15 September 2025

**Re: Global Stability Study for Eastern Slope near Building D
West Essex – Highlands Development
West Orange, New Jersey
Langan Project No.: 101049801**

As requested, in conjunction with the above-referenced study Langan Engineering and Environmental Services, LLC (Langan) has reviewed letters prepared by Princeton Hydro ("Princeton"), who has been retained by Objectors to the proposed Development. The Princeton letter, dated 16 July 2025, summarized their comments under four primary issues (below):

Cross Section A_Proposed Condition
(GSI = 65)

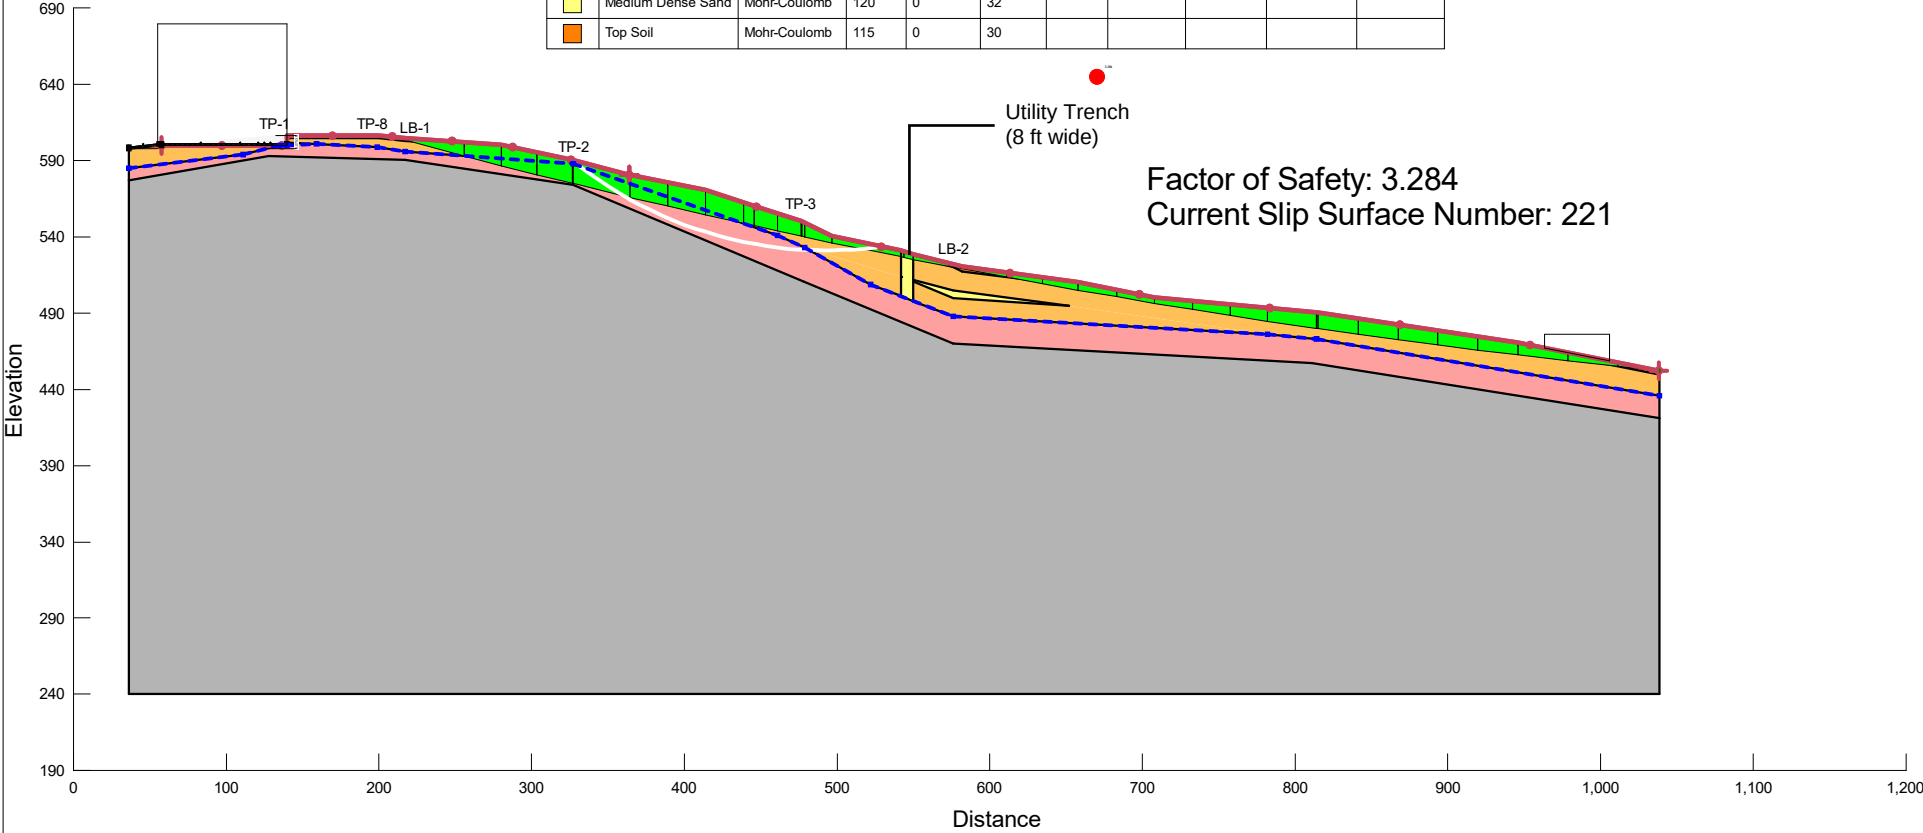
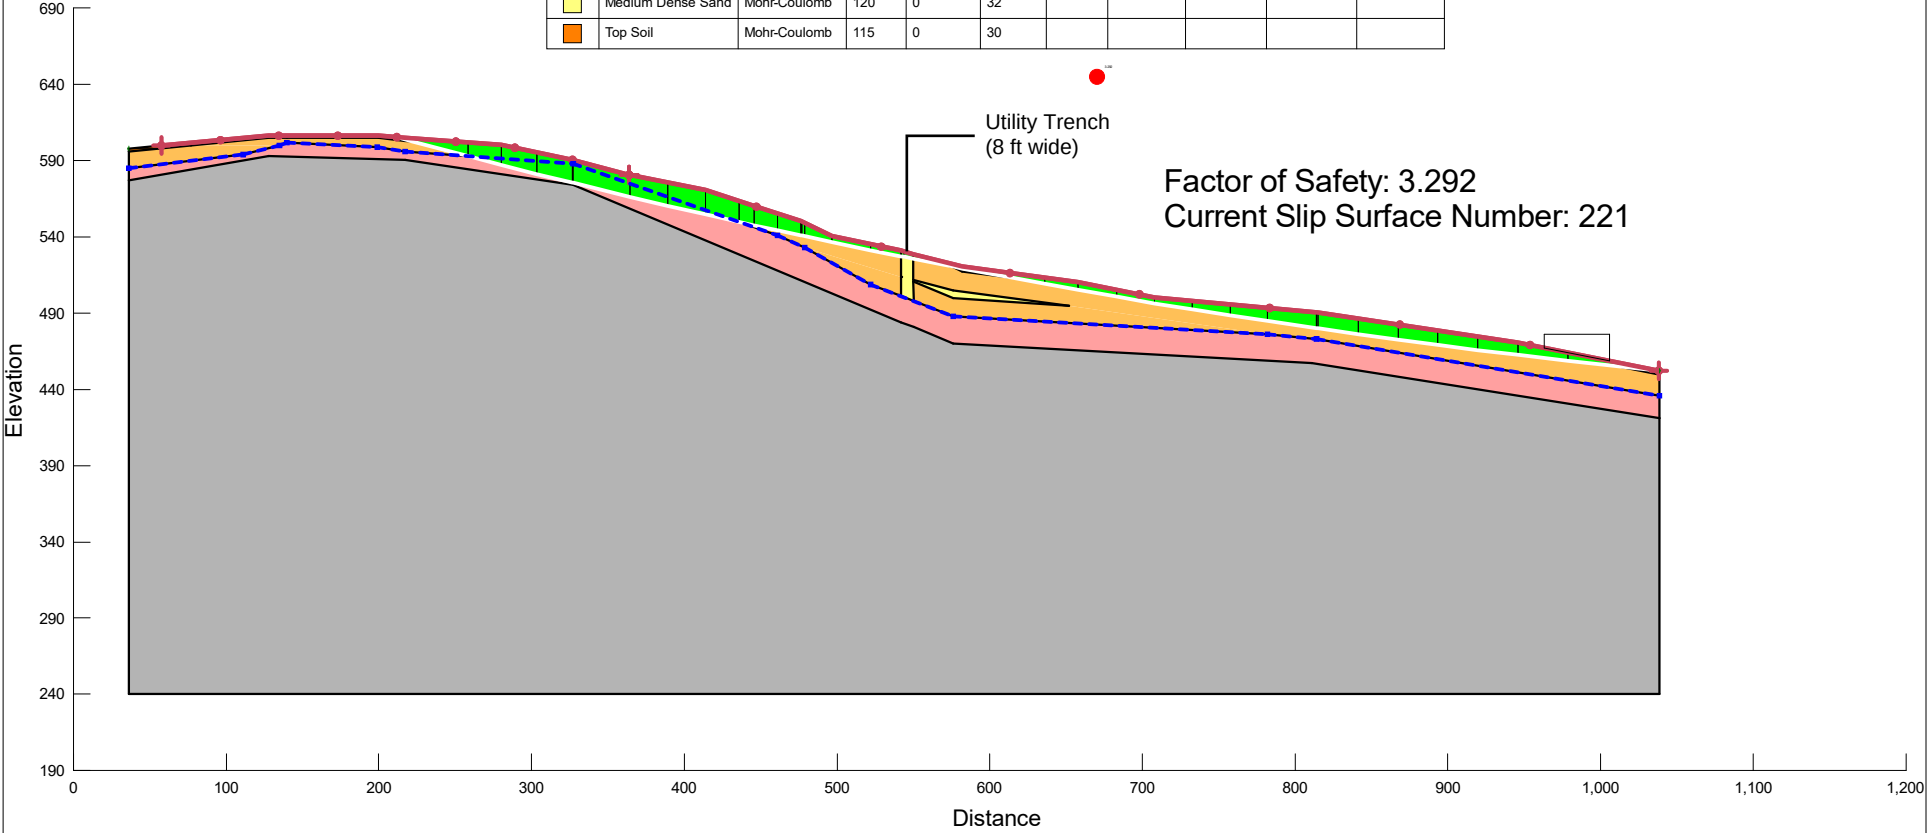
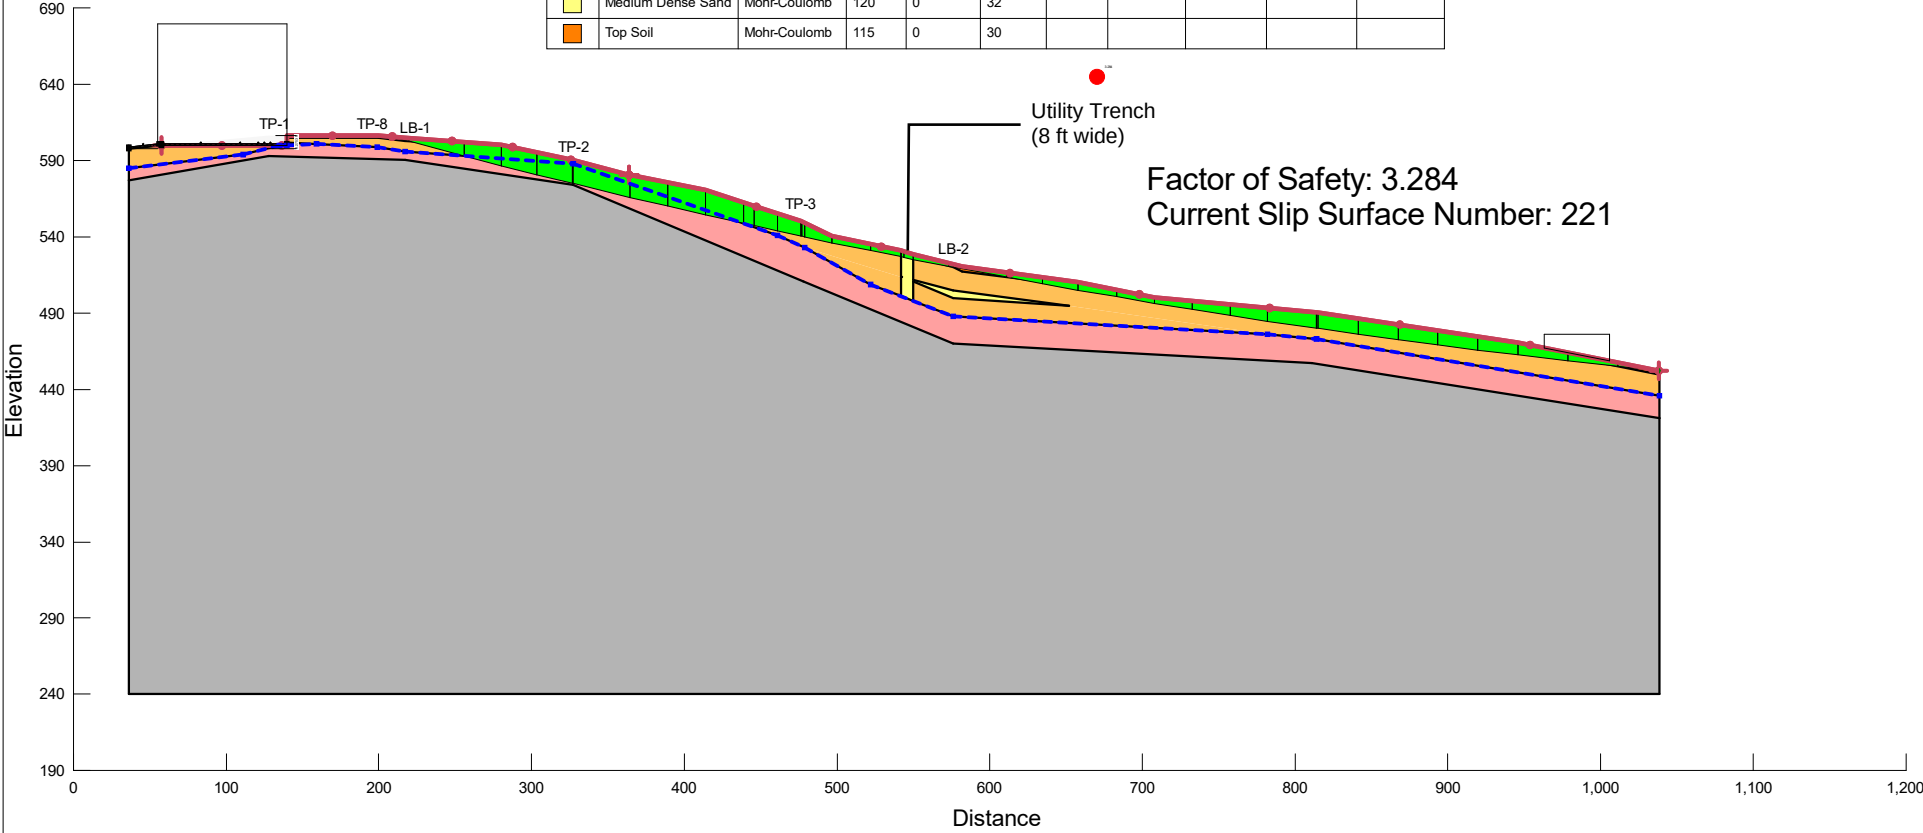
Langan Response: Princeton initially identified seven subparts associated with their position. Five of 7 relate to rock properties used in our model, one relates to building loading, and one relates to the presence of a sewer. In Princeton's 12 August letter they provided analyses using their interpretation of our data. Overall, Princeton repeatedly claims our design values are incorrect, yet they clearly misinterpret the data and mis-apply it.

We modeled our analysis sections A-A and B-B with the discontinuity of the wastewater utility line as a trench of medium dense sand having a friction value of 32 degrees extending from ground surface to the decomposed rock over 30 feet below the existing grade. Our models show that there is no change in the location of the critical failure surfaces or corresponding factors of safety (Exhibit B).
